UNITED STATES
DEPARTMENT OF THE INTERIOR
BUREAU OF LAND MANAGEMENT**SUNDRY NOTICES AND REPORTS ON WELLS**
*Do not use this form for proposals to drill or to re-enter an abandoned well. Use form 3160-3 (APD) for such proposals.*FORM APPROVED
OMB NO. 1004-0135
Expires: July 31, 2010

☒ Oil Well ☐ Gas Well ☐ Other2. Name of Operator
SM ENERGYContact: VICKIE MARTINEZ
E-Mail: VMARTINEZ@SM-ENERGY.COM8. Well Name and No
OSAGE 34 FEDERAL COM 3H9. API Well No.
30-015-39785-00-X13a. Address
3300 N A ST BLDG 7 STE 200
MIDLAND, TX 797053b. Phone No. (include area code)
Ph: 432-688-1709
Fx: 432-688-170110. Field and Pool, or Exploratory
PARKWAY

The following changes are requested to be made to the Osage Federal 34 ? 3H:

CONDITIONS OF APPROVAL

MINIMUM BLOWOUT PREVENTER REQUIREMENTS

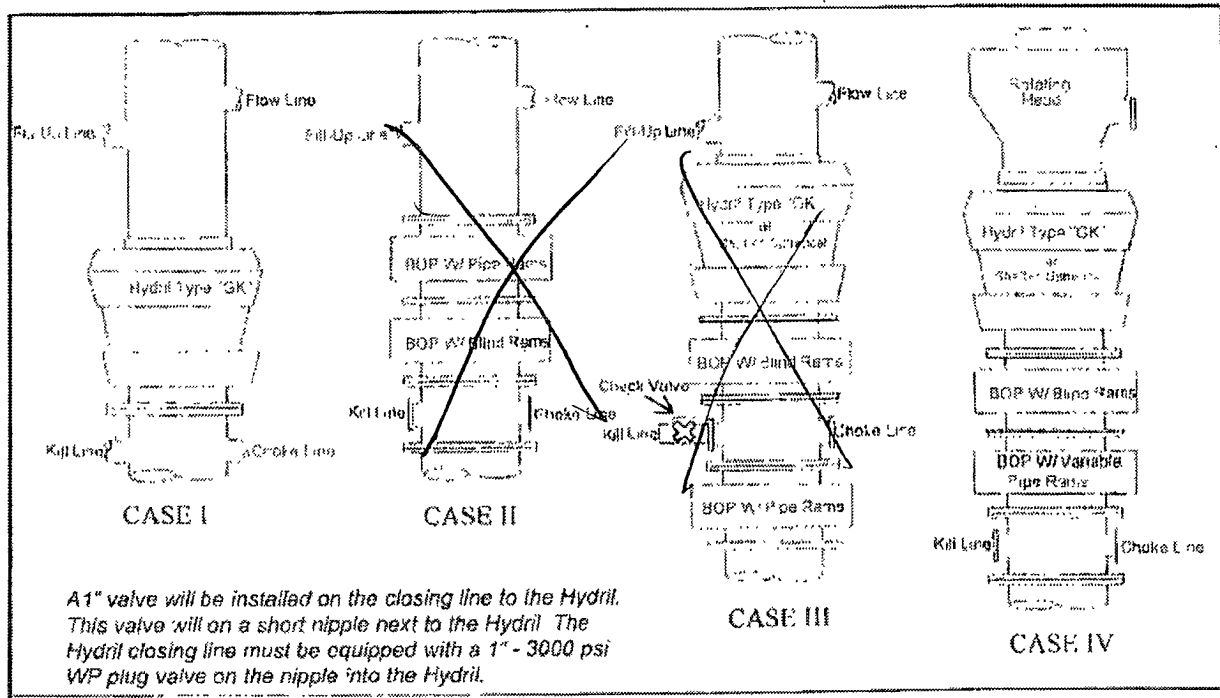
Change 4:

SM Energy would like to request the use of a 3M annular be used after surface on the 13-3/8" Casing as seen in Case 1.

Once the 9-5/8" Casing is set a 5M annular and 5M double rams will be set on 9-5/8" casing and will remain for the remainder of the well. This set up is seen in Case IV.

PRESSURE CONTROL

2. Minimum working pressure of the blowout preventer (BOP) and related equipment (BOPE) required for drilling below the 13-3/8 inch first intermediate casing shoe shall be **2000 (2M)** psi.

3. Minimum working pressure of the blowout preventer (BOP) and related equipment (BOPE) required for drilling below the 9-5/8 intermediate casing shoe shall be **3000 (3M)** psi. Operator installing 5M system and testing as a 3M system.
